COMMENTS FOR VALLCO SHOPPING DISTRICT SPECIFIC PLAN DEIR

Draft Environmental Impact Report SCH# 2018022021

JUNE 6, 2018

Kitty Moore

Figure 4: DEIR Heights

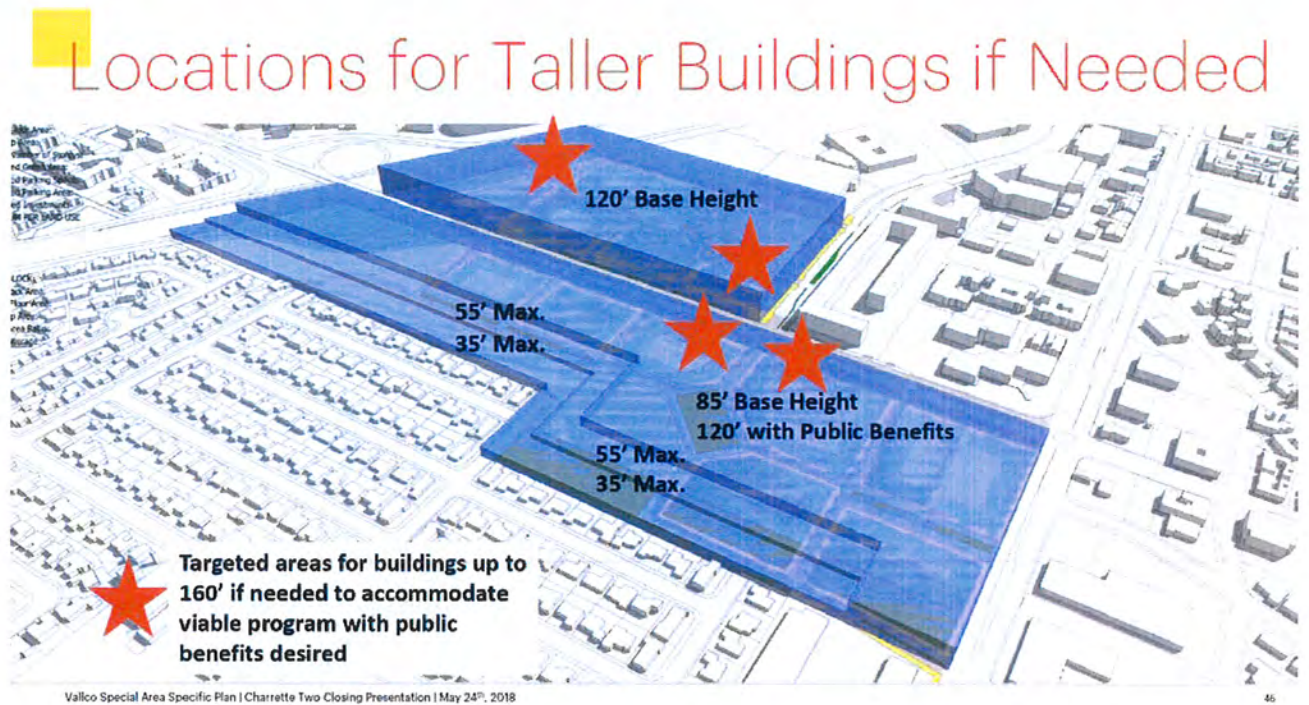
3. 65,000 SF of civic space, STEM lab, and 30 acre green roof were not discussed in the NOP period for Vallco. In the DEIR civic space and STEM lab are combined into the 65,000 SF. Additionally, the civic/STEM spaces are considered public benefits which would result in higher building heights if the developer includes them. This was mentioned at the Opticos Charrette #2 closing presentation, May 24, 2018:

- To add to the confusion as to what the project may end up being, the maximum height was also shown to be 294'. These height differences will cause different shadow and intrusion issues, such as privacy intrusion into Apple Campus HQ which may be a security risk at the corporate headquarters, guest discomfort at the outdoor swimming pool at Hyatt House, and the lack of privacy for the area homes and back yards. In Section 4.2.1 of the DEIR, heights are shown up to 165'.

Figure 8: Vallico Specific Plan Process Alternatives to Date (self)

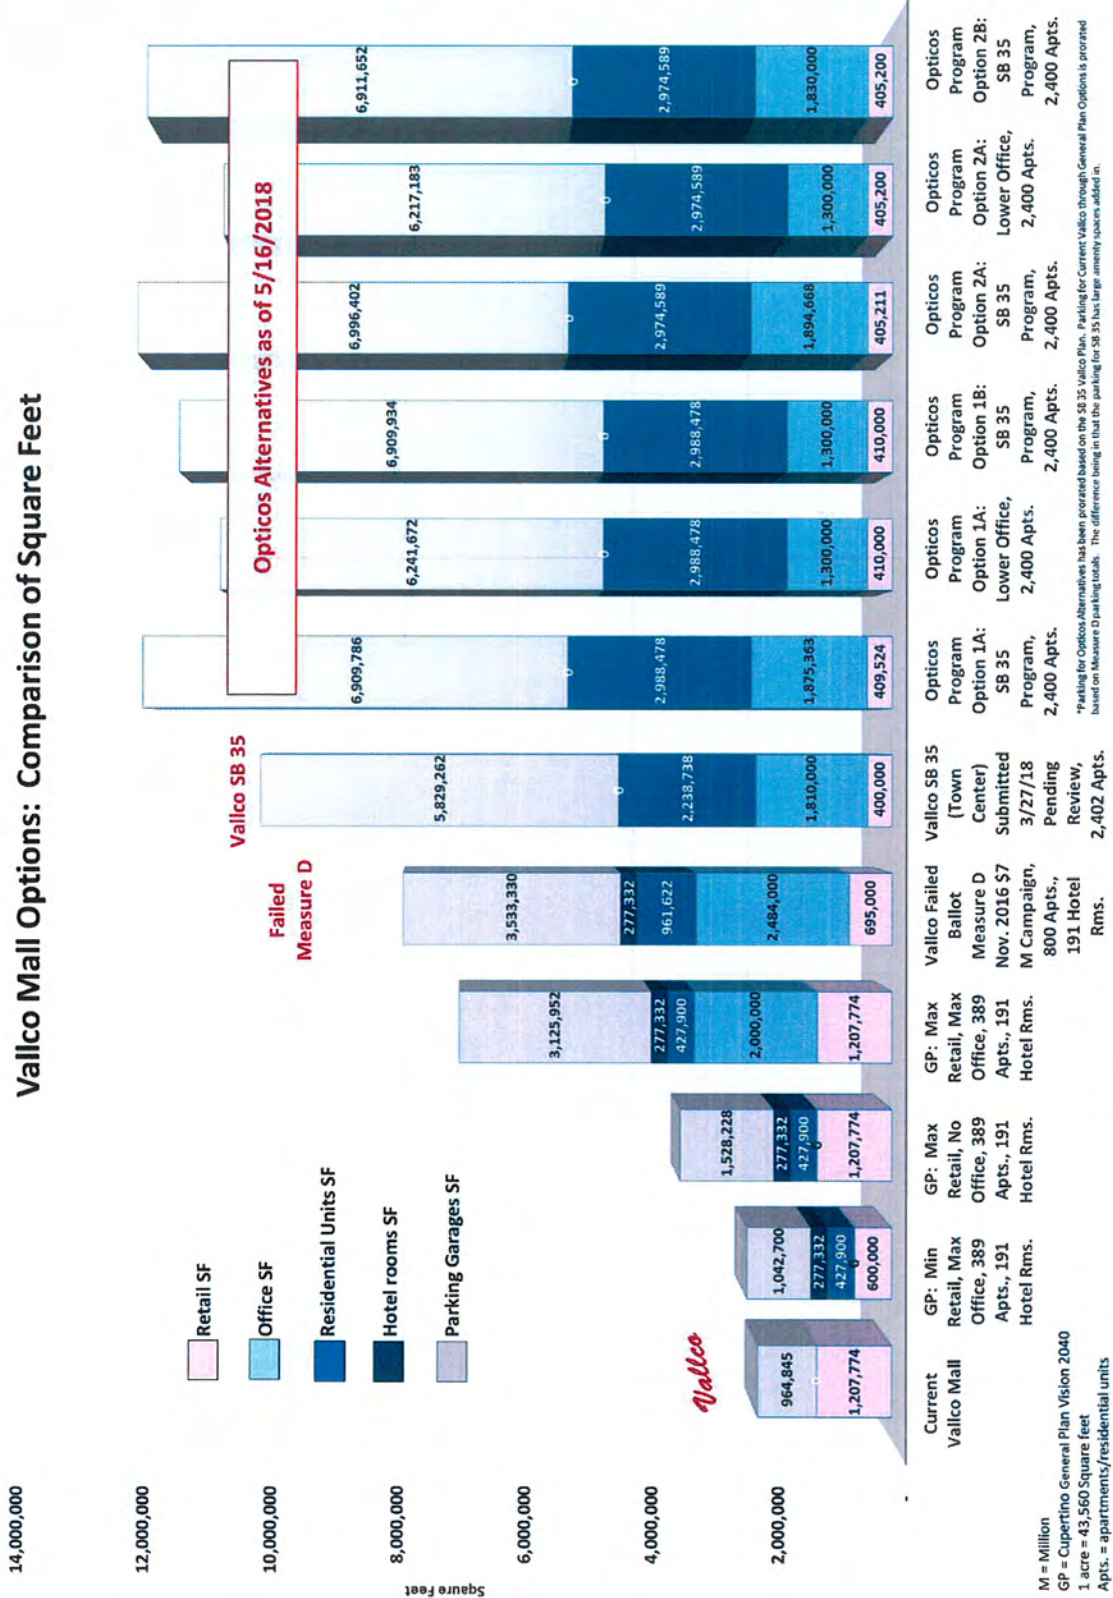
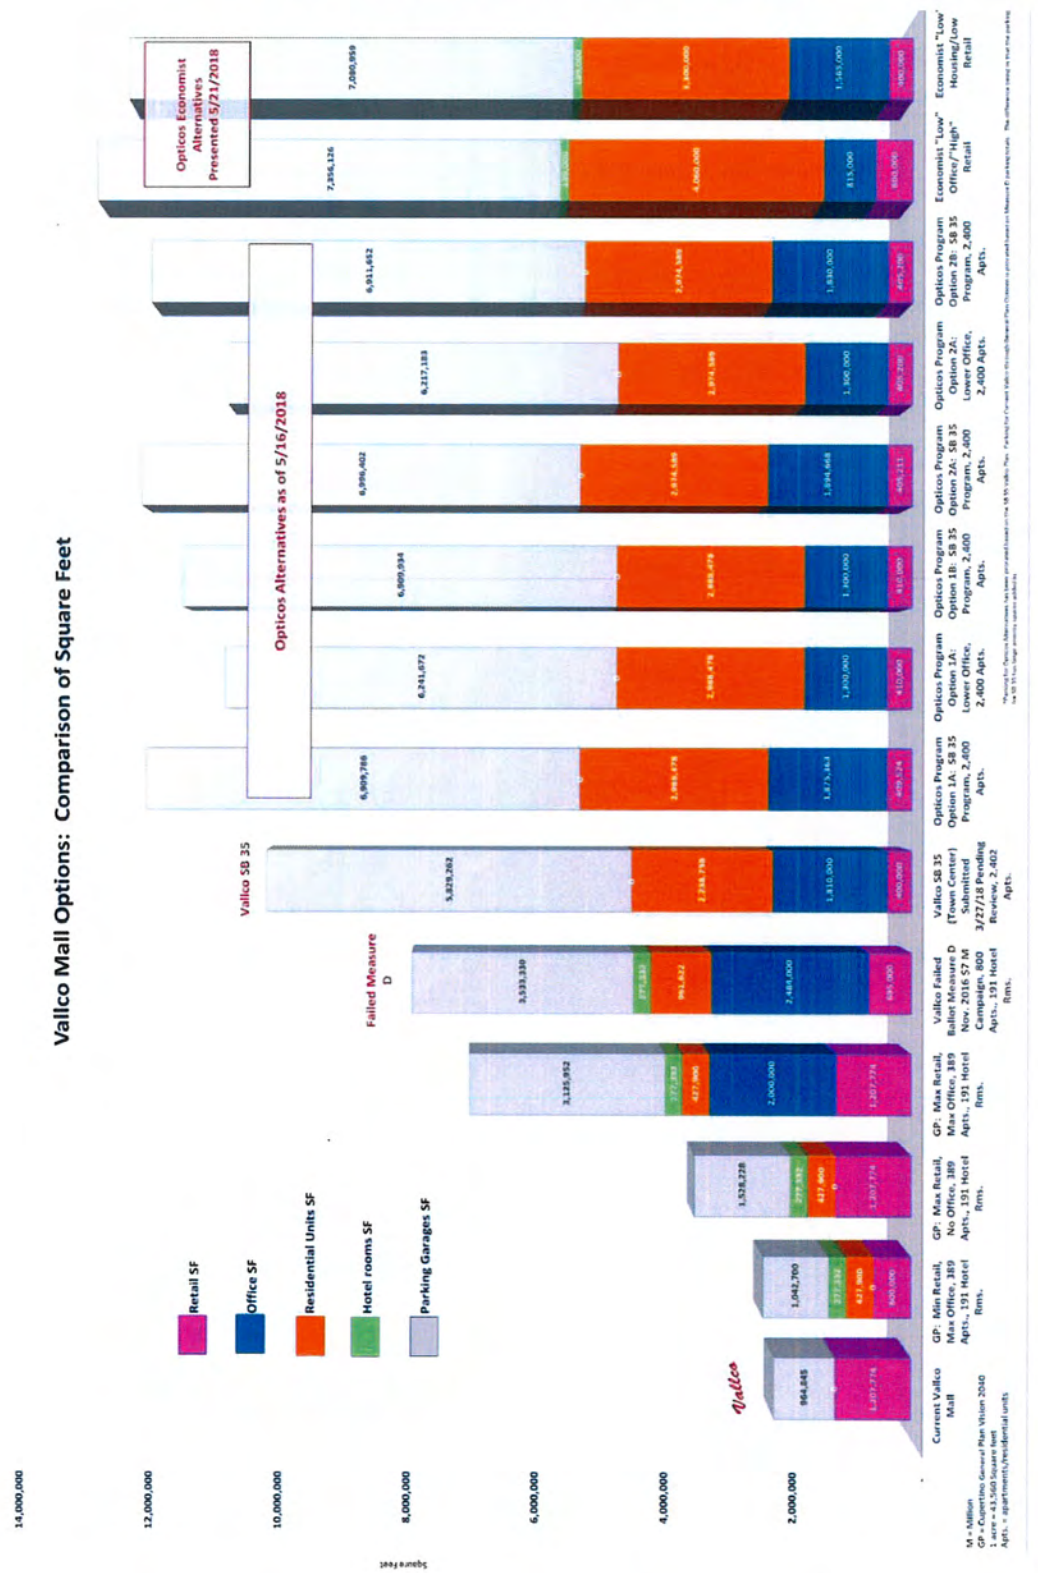
9. The Specific Plan must be consistent with the General Plan by law. We have no identified Specific Plan and the last alternatives presented at the final Charrette #2 do not match any alternatives studied in the DEIR (3,200 residential units along with 750,000-1,000,000 SF office space plus 65,000 SF civic space) and are not consistent with the General Plan.

Figure 18: Valco 1965

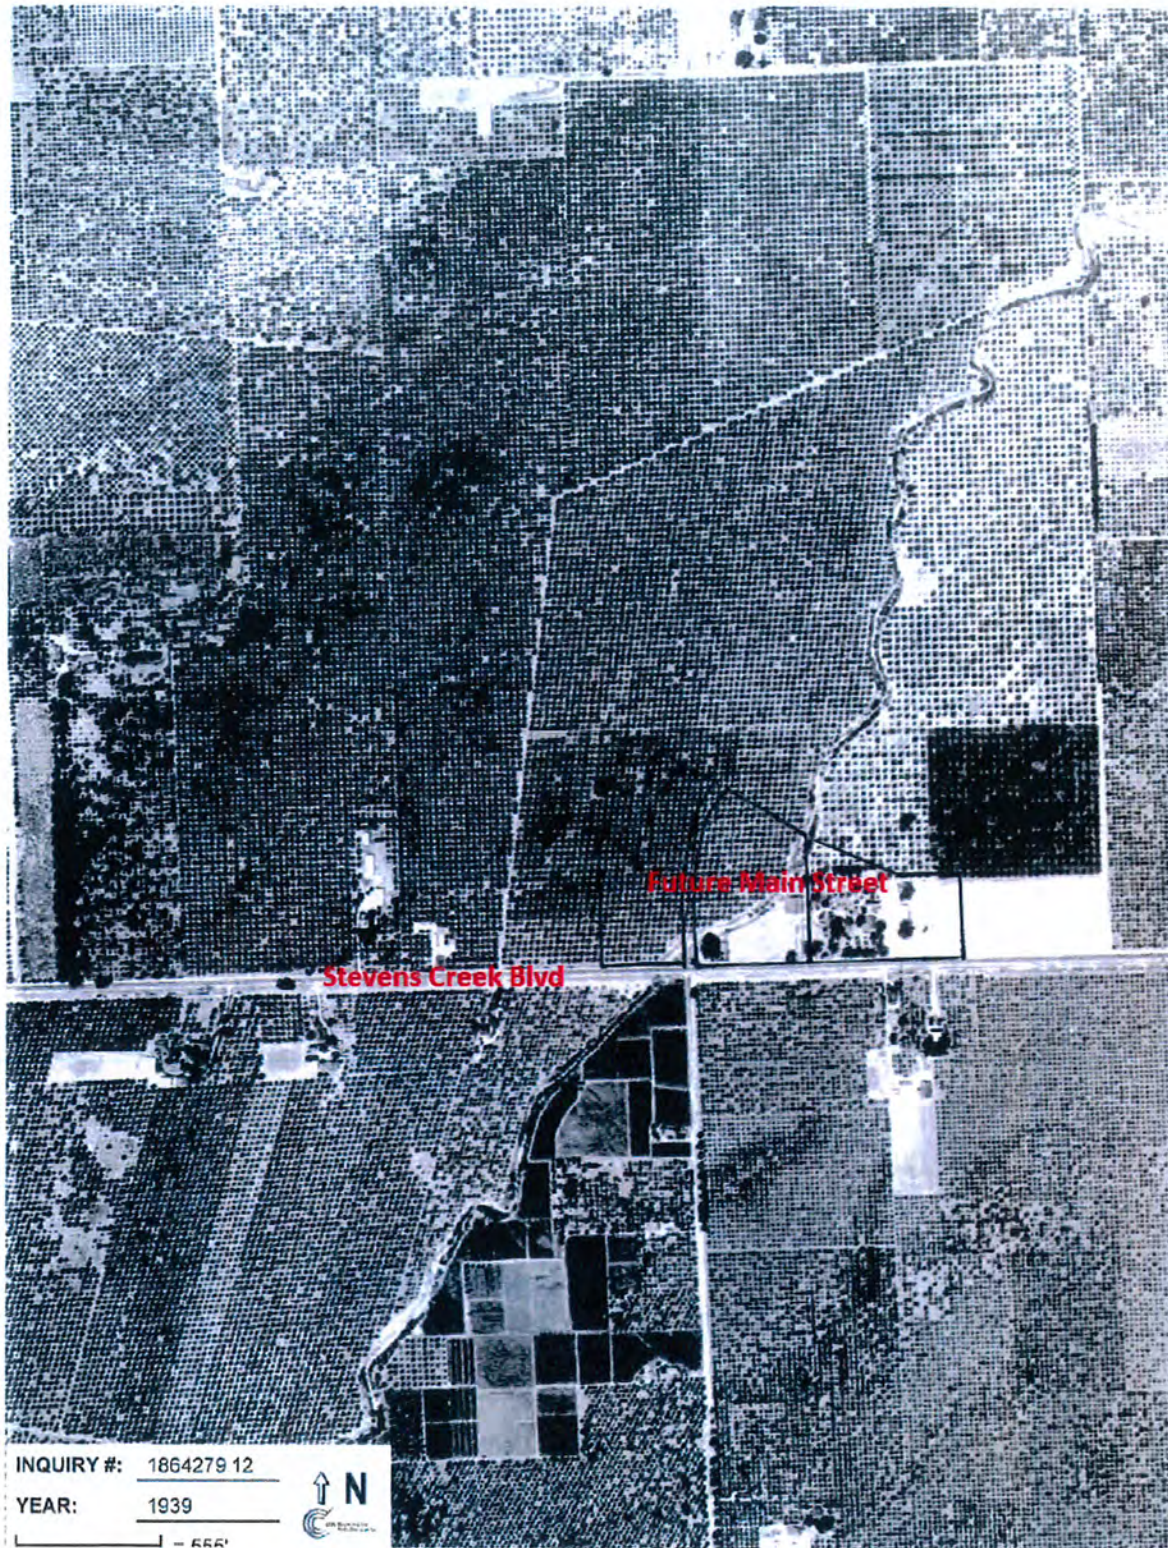
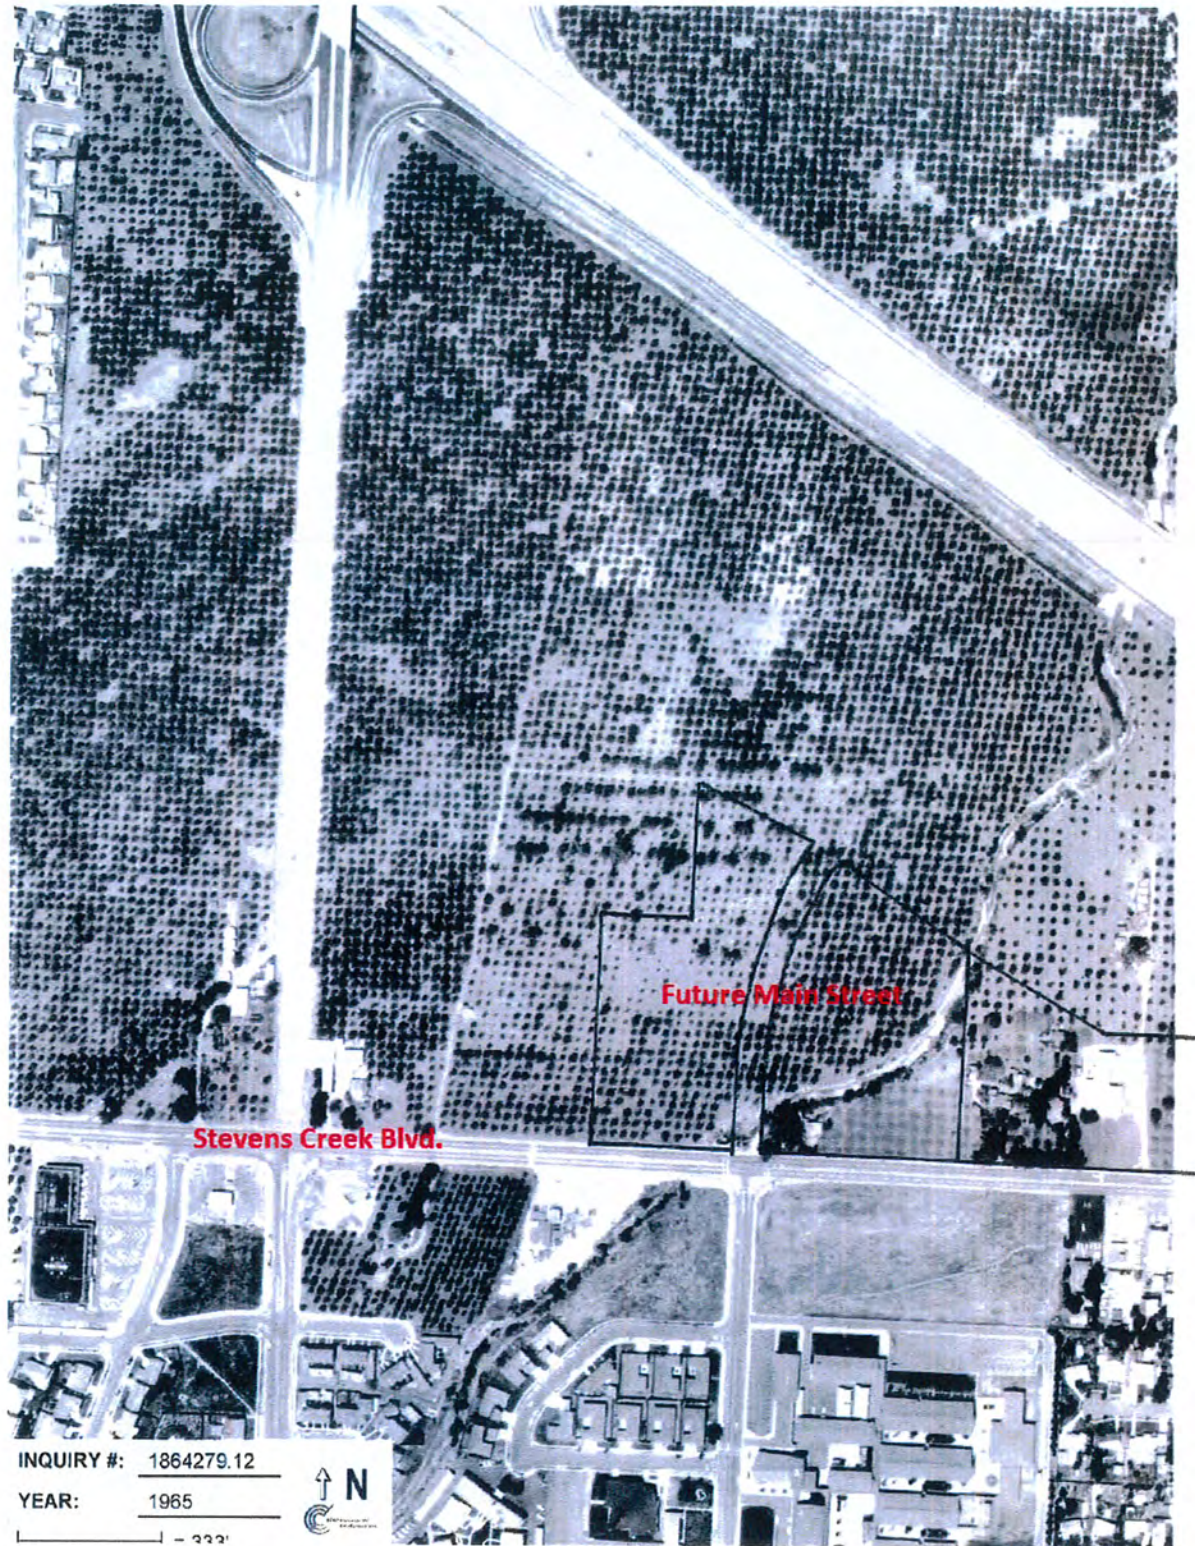
The following historical photographs indicate how the corner has never had the view blocked by any solid structure:

Figure 25: AQI from BAAQMD

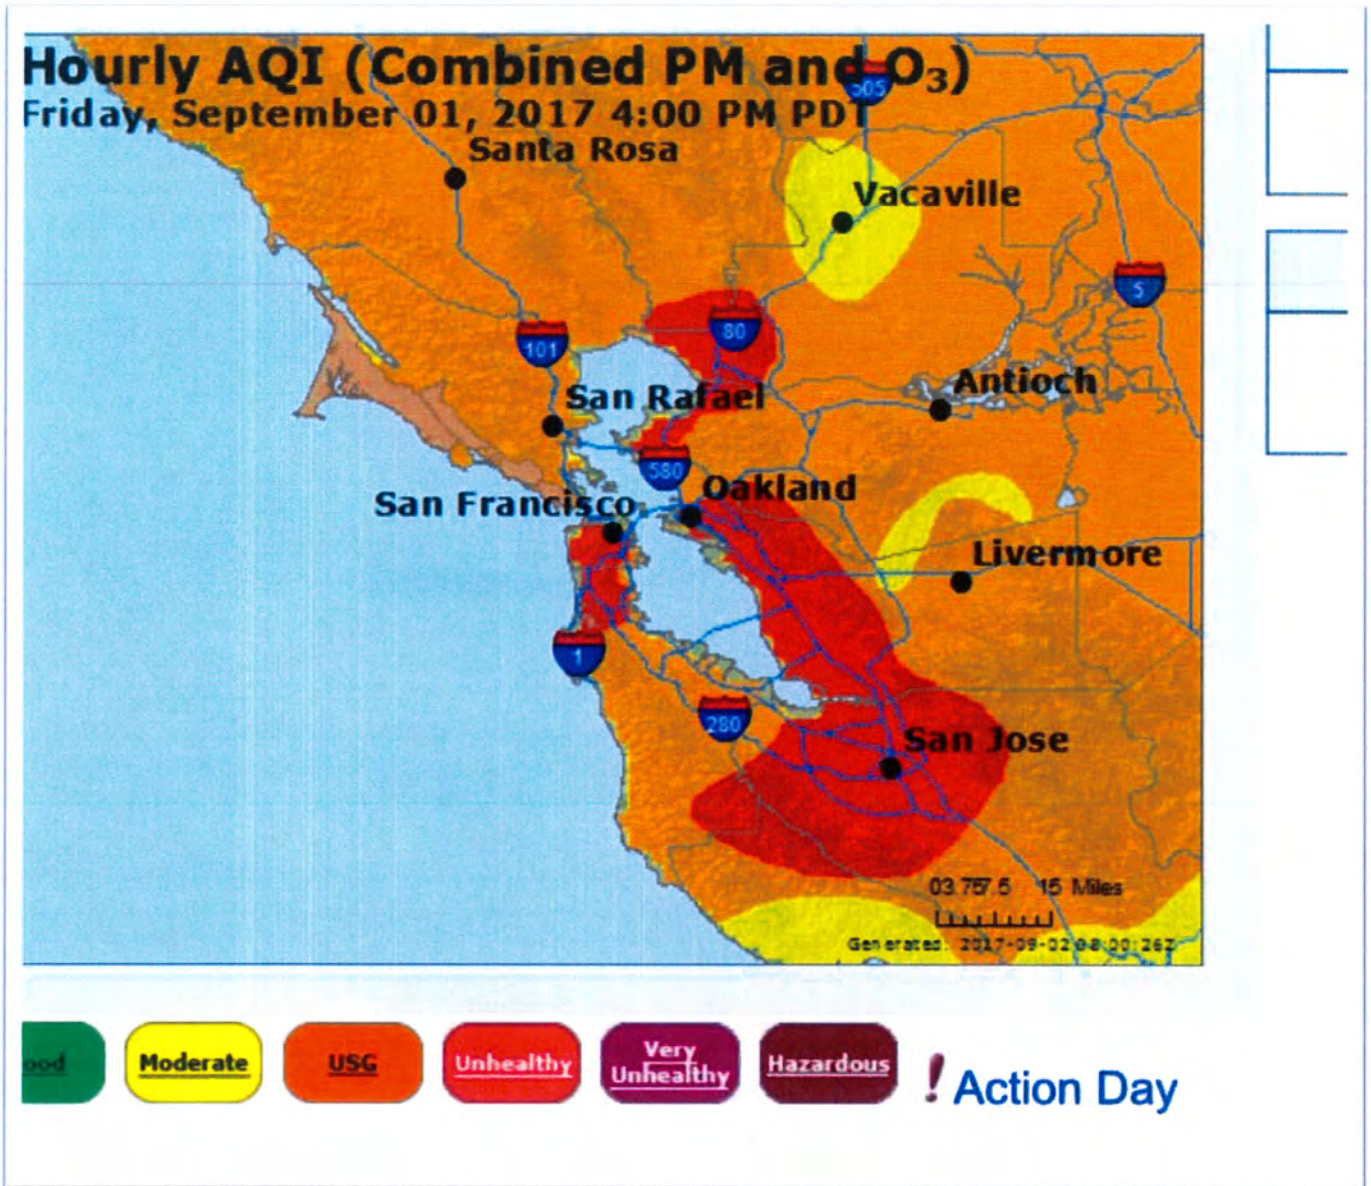
The cancer risk assessment is based on erroneous traffic studies and the air quality monitoring stations had old data from 2013 and/or were too far away to use data. The cancer risk needs to be recalculated. The amount of exposure time should reflect seniors not leaving the project area. The baseline air quality monitoring must be taken over an extended period with particular attention paid to the summer months when Ozone levels increase. Here is an example day when children would be playing outdoors, Ozone was the primary pollutant. Note these are regional amounts, and the increases along the freeways are not shown:

The I-280 freeway produces substantial TAC pollutant concentrations and the south bay is subjected to the entire bay area's pollutants which are converted to Ozone in the warm summer months. The DEIR failed to monitor air pollution for the site for any time period, and only modeled pollutants onsite. Fires are expected to be the new normal, bringing potential further impacts to the region's air quality.

Figure 30: SB 35 Valco Subterranean Parking Plan

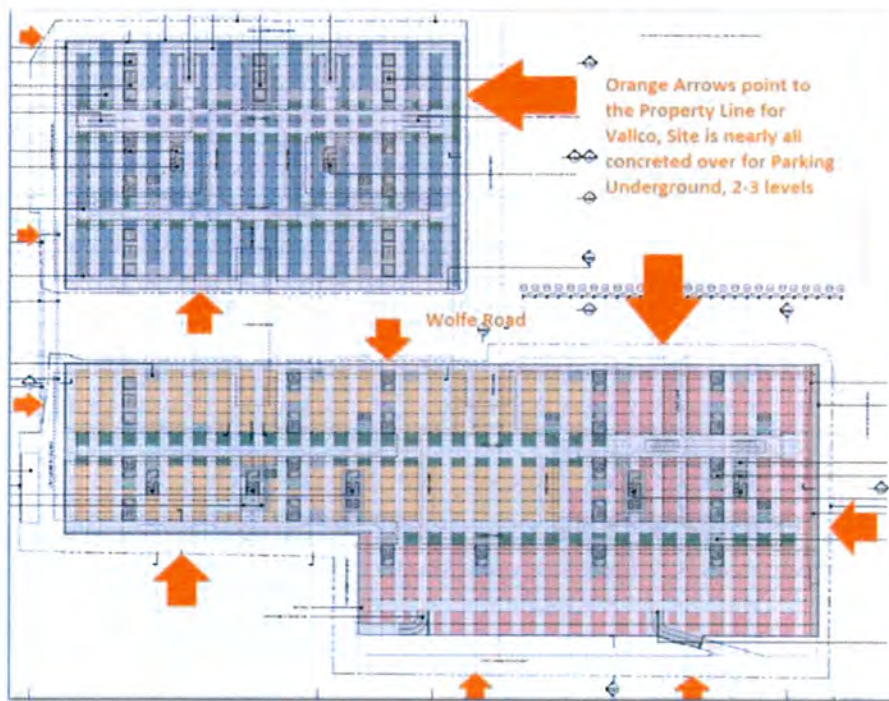
Plans from the Specific Plan process are not finalized but have all shown 2 levels of underground parking. The site location across the freeway and massive Apple Park parking garages make it even more impacted by the freeway because 14,200 Apple employees will work at that site (according to Cupertino Mayor Paul, 6,000 employees had occupied the site as of March, 2018 up from a few hundred in December, 2017) and have acceleration and deceleration off the freeway at the Wolfe Rd. exit.

2 Million CY of soil export assumption may be increased due to the Specific Plan process currently stating 85% of parking will be subterranean.
